Recall Campaign Bulletin

Campaign No. 2024070005, July 2024

SUBJECT: **Model C-Class (206 platform)**
Model Year 2022 – 2023

Check Pre-Fuse Box Wiring

Figure 1

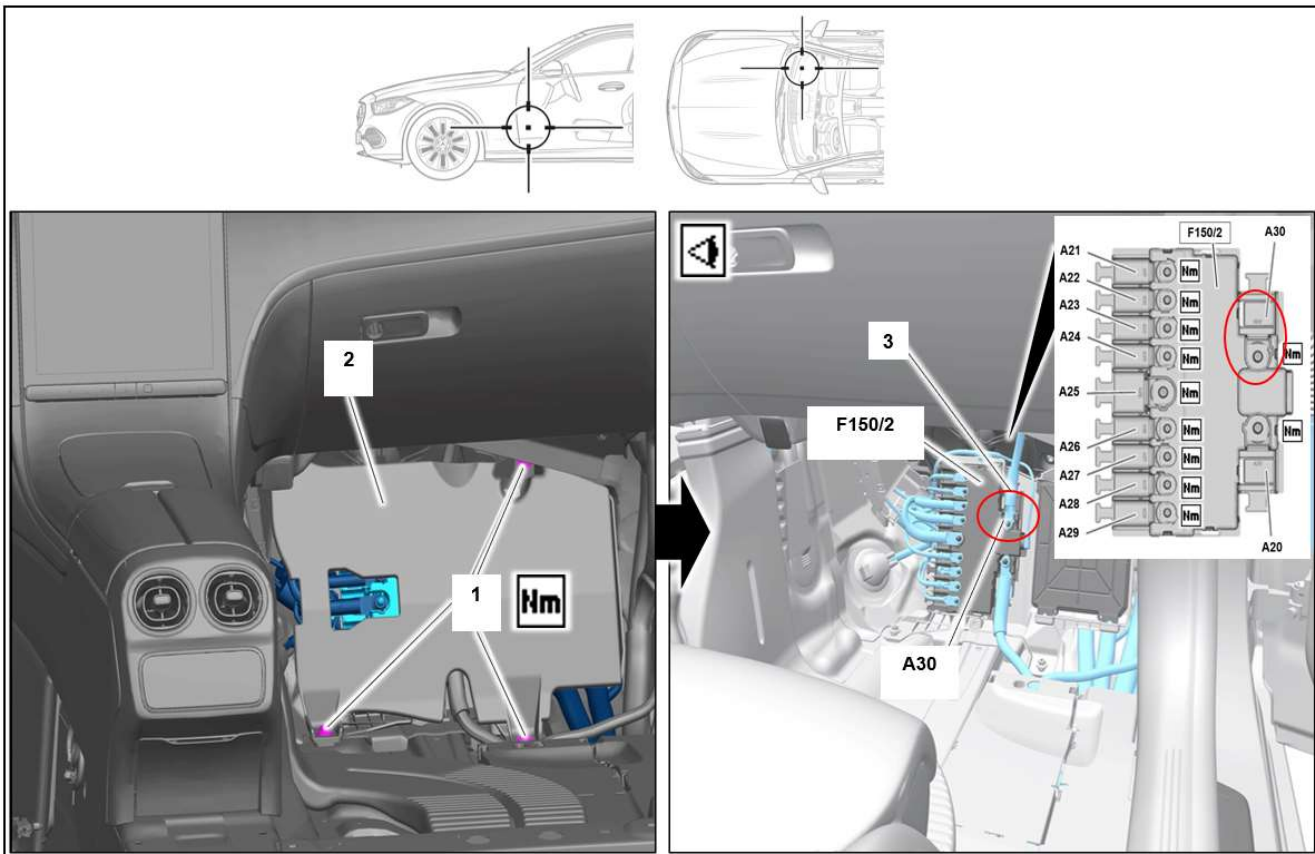
1. Remove floor covering on front passenger side.
i For basic information, see **AR68.80-P-0008WT**.
2. Disconnect ground line of 12 V on-board electrical system battery.
i For basic information, see **AR54.10-P-0051WT**.
3. Remove passenger side footwell support (**Figure 1, 2**).
i For this purpose, remove nuts (**Figure 1, 1**).
i For basic information, see **AR54.15-P-1350WT**.
i **Installation:** Tighten nuts (**Figure 1, 1**) with the specified tightening torque of **6 Nm**.
